AGENDA

**CITY OF COLUMBIA TENNESSEE
BOARD OF ZONING APPEALS
STAFF REPORT**

**DOCKET/CASE/APPLICATION
NUMBER**
22-0200

Case #22-0183
Vulcan Quarry
TM 66 Parcels 20.25 & 20.26

Site Location
 MAURY COUNTY
 COLUMBIA, TENNESSEE

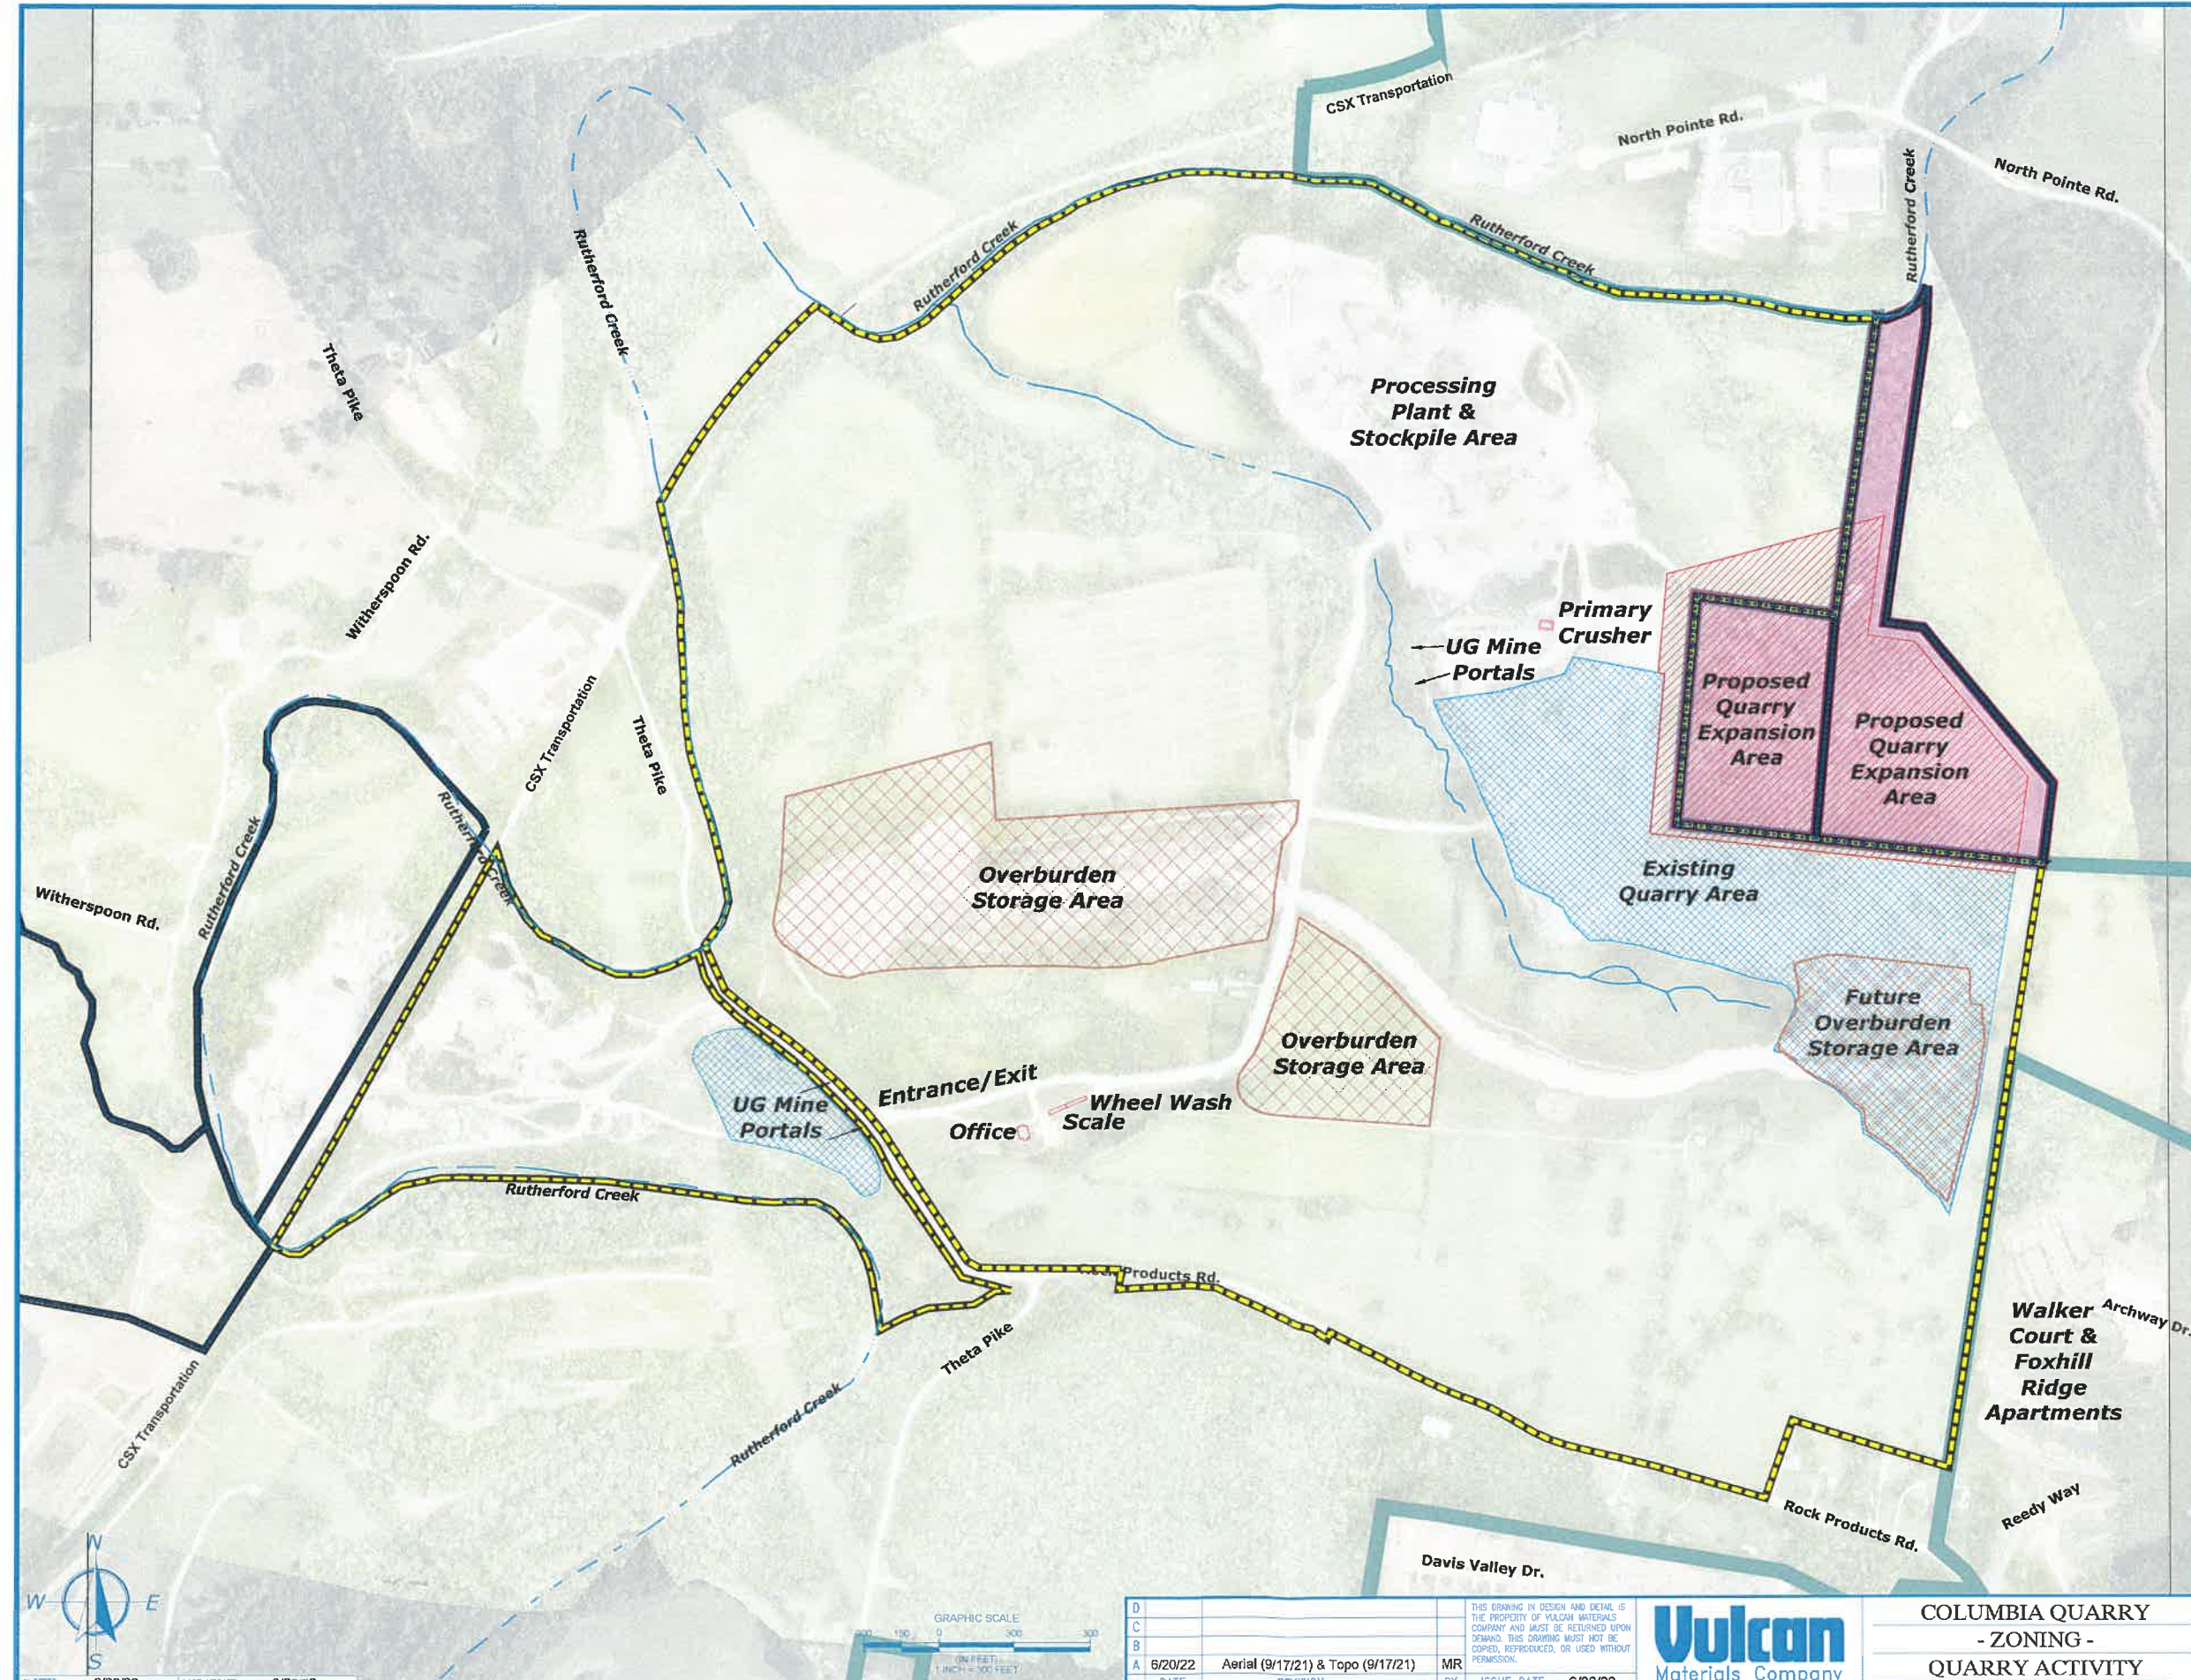
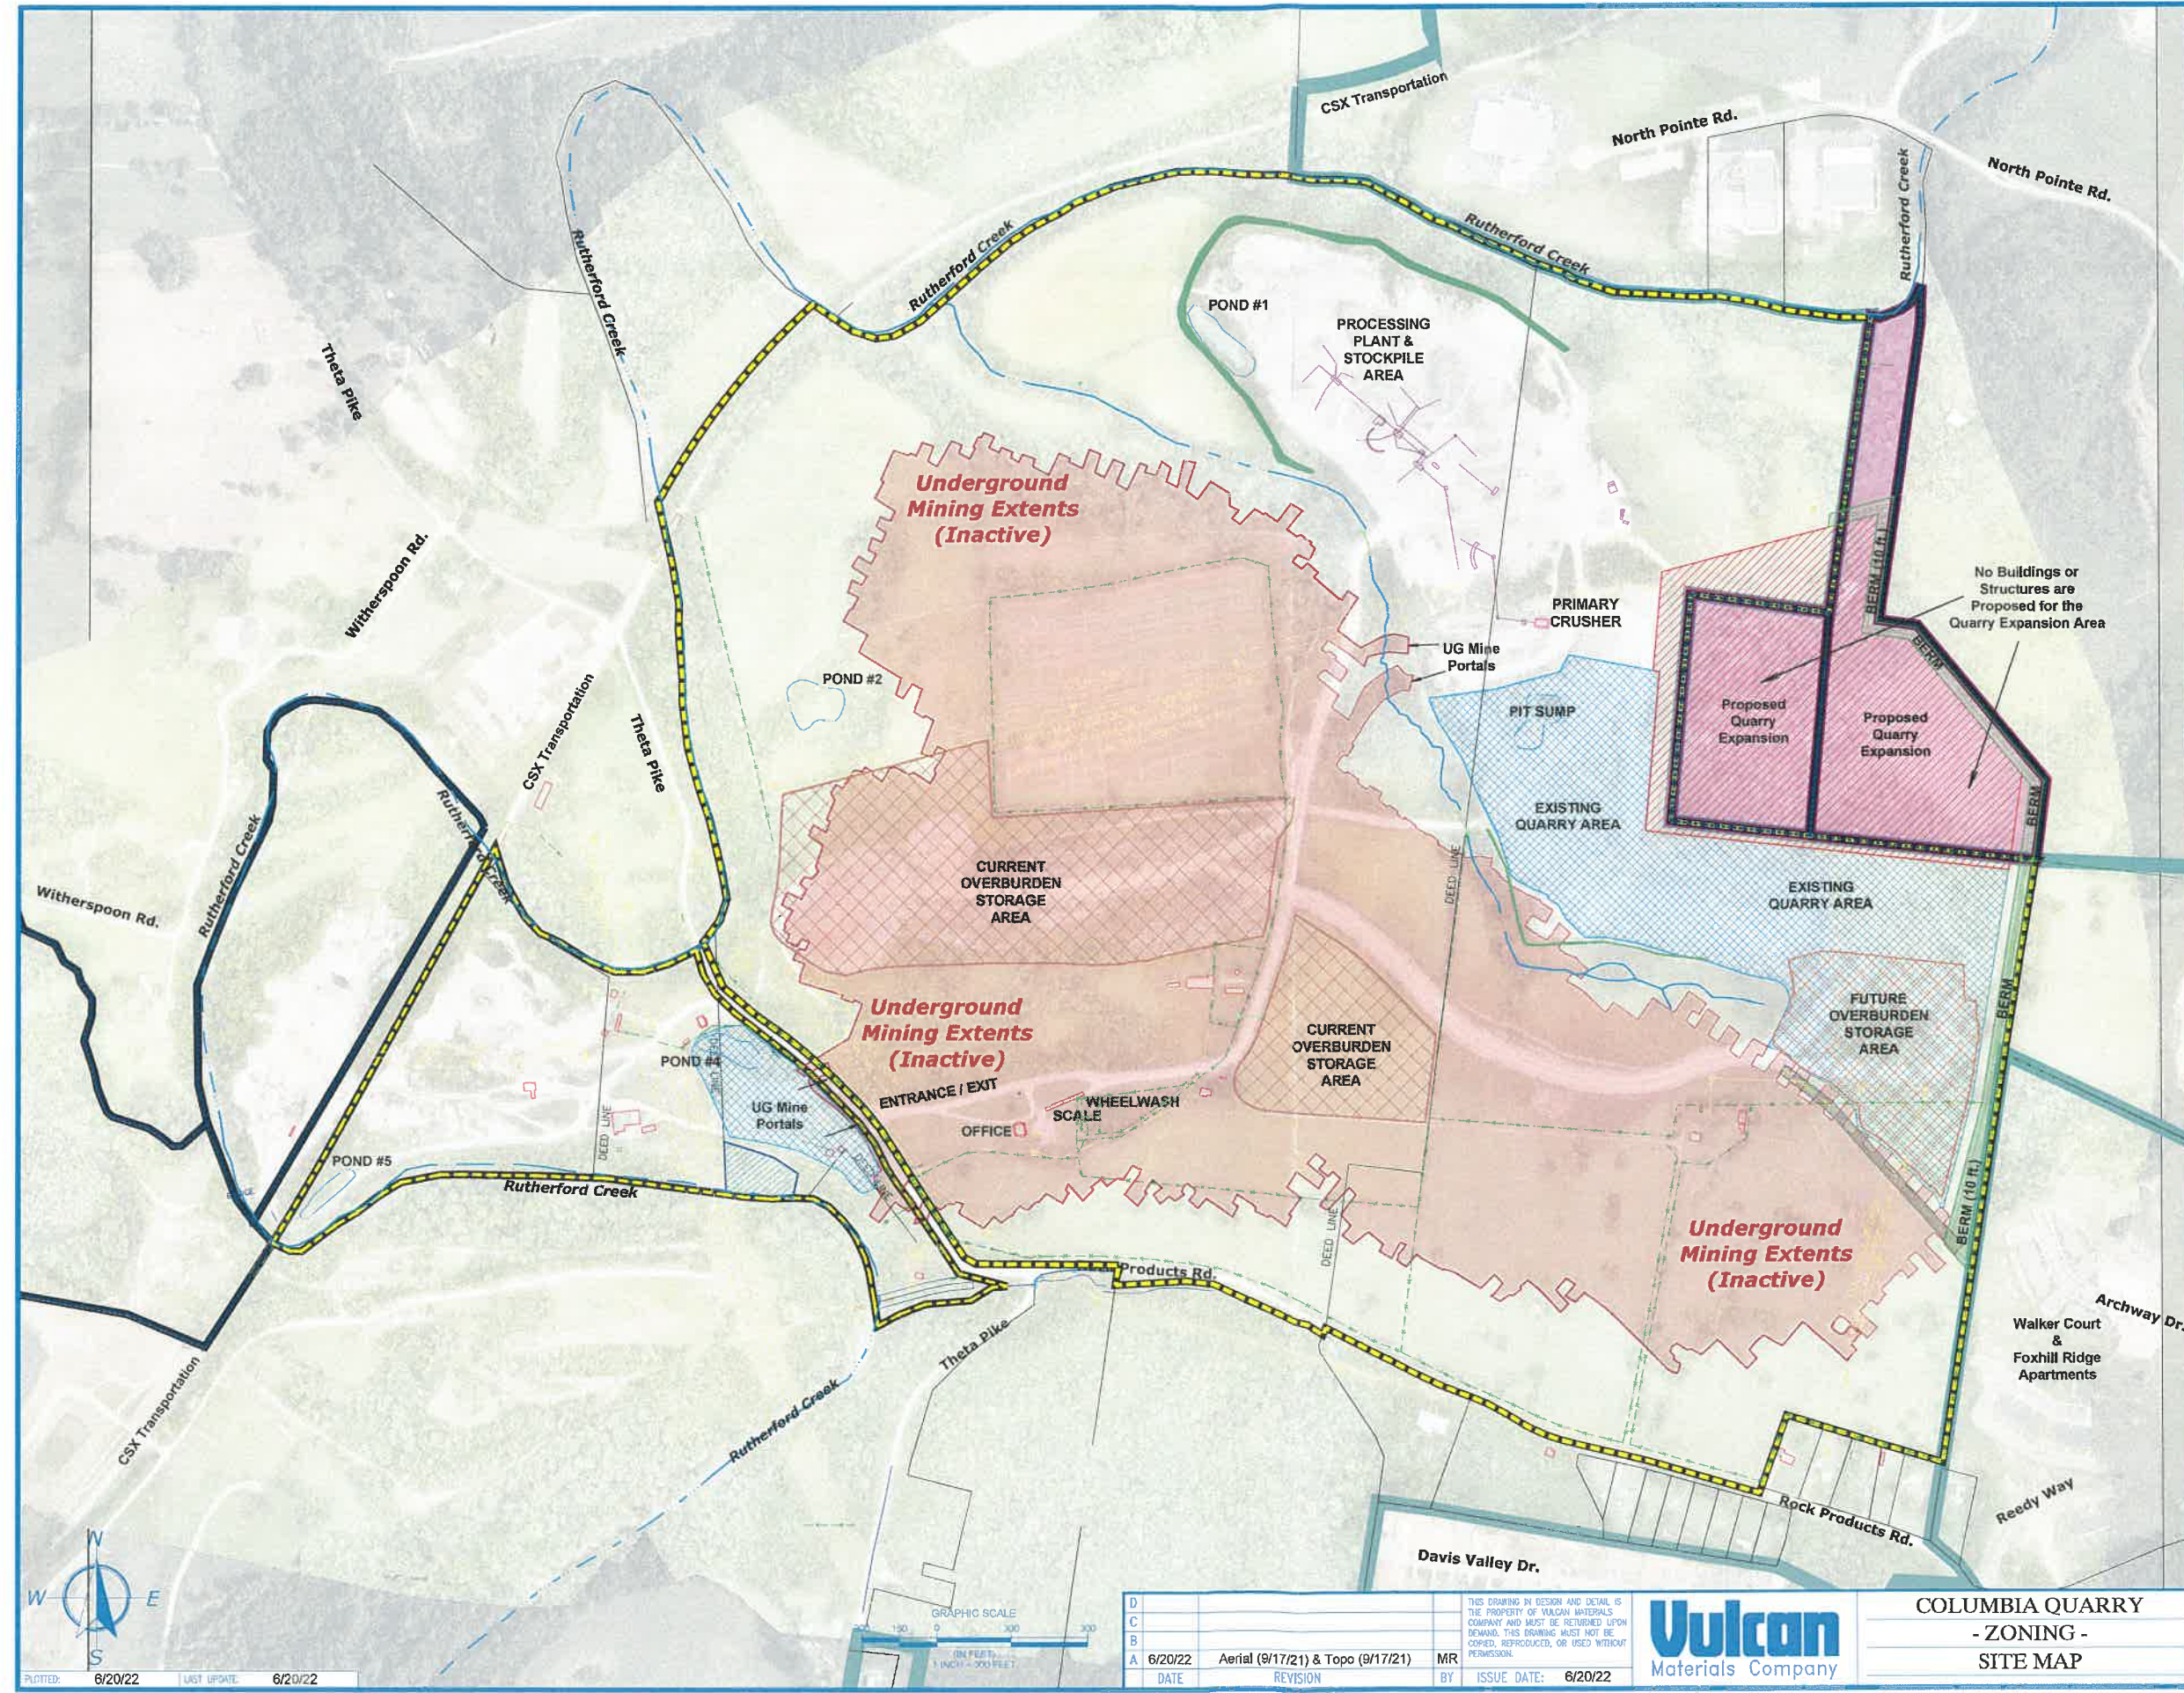
The Zoning Ordinance requires that every mining operation established in the city provide a plan for restoration of the site (8.3.1.C.1). The applicant's plan is illustrated at Exhibit I of the submittal and further described in the letter from the applicant's representative. Specifically, the applicant proposes to reduce the slope of the site using fill materials. The remaining "pit" will become a water feature and the site will be planted with native foliage. The Ordinance does not prescribe technical requirements for restoration of the site. The applicant's proposal appears to be in keeping with industry standard and the common practice for retiring exhausted quarries across Tennessee.

The Ordinance requires that a detailed site plan accompany every request to establish or expand a quarry operation (8.3.1.C.4). The applicant has provided a site plan comprised of Exhibits A through I of the submittal. The plan depicts the existing contours of the site and its vicinity at 2-foot intervals (8.3.1.C.4a and b), the method of drainage (8.3.1.C.4d), and the plan for restoring the site (8.3.1.C.1 and 8.3.1.C.4d).
